CALIFORNIA ENERGY COMMISSION

Clay Jensen, Senior Director
BrightSource Energy, Inc.
1999 Harrison Street, Ste. 2150
Oakland, CA 94612**RE: HIDDEN HILLS SOLAR ELECTRIC GENERATING SYSTEM (11-AFC-2), DATA REQUESTS, SET 2E (#'s 177-188)**

**APPLICATION FOR CERTIFICATION
FOR THE *HIDDEN HILLS SOLAR ELECTRIC
GENERATING SYSTEM***

Figure 1 above represents the spectrum of the photopic luminous efficiency function, V_{λ} (black), and a representative solar spectrum (Wehrli, red). The visual response (green) represents the visual systems sensitivity to the solar spectrum.

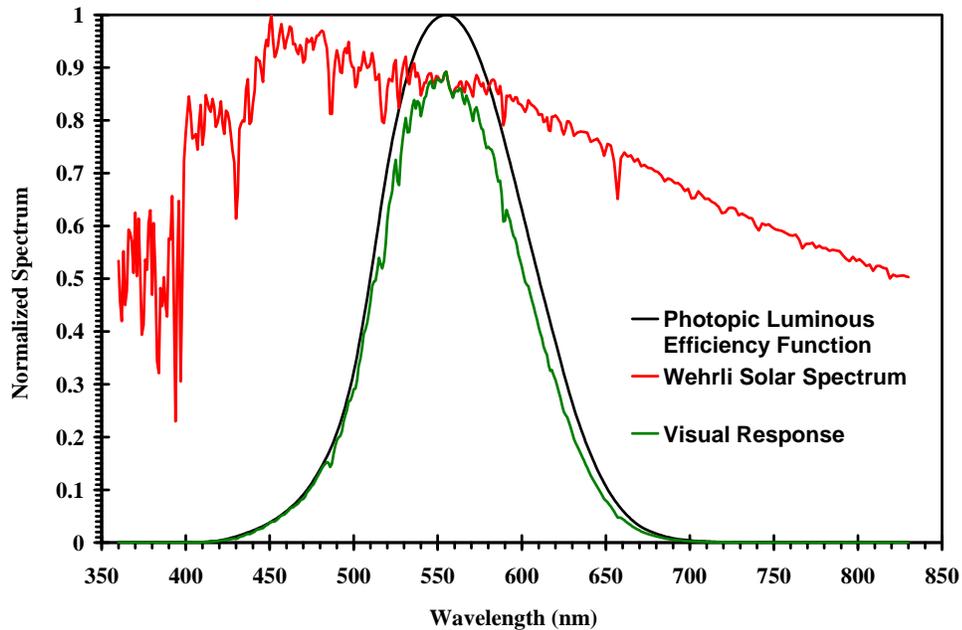
This statement is true for the consideration of physiologic damage. However, luminance is absolutely necessary for any determination of perceived brightness. The human photopic luminous efficiency function for the Standard Observer, V_λ , defines the envelope of human visual sensitivity as a function of visible wavelengths. This is shown in **Figure 1** (below) together with a representative solar spectrum (Wehrli) and the visual response/sensitivity profile to the Wehrli spectrum. It is the integrated visual response which defines luminance and contributes to perceived brightness. Staff recognizes that the relationship between luminance and brightness is not straightforward and depends on additional factors such as the observer's state of adaptation, the spatial extent of the SRSG source, and the context/background luminance. Although, as the applicant states in their response, the retinal irradiance (E_r) of the SRSG is significantly less than that of the sun, it is still on the order of approximately 30-40 times greater than that of the sky background. Staff considers this potentially significant and desires an understanding of the luminance of the SRSG during operations and its relationship to the luminance of the sky background.

186. Please provide estimates of the luminance of the SRSG during operations and the luminance of representative sky background. Please address the impact of these values and their relationship on apparent brightness, glare and visual disruption at nominal viewing distances for workers, the public and motorists.
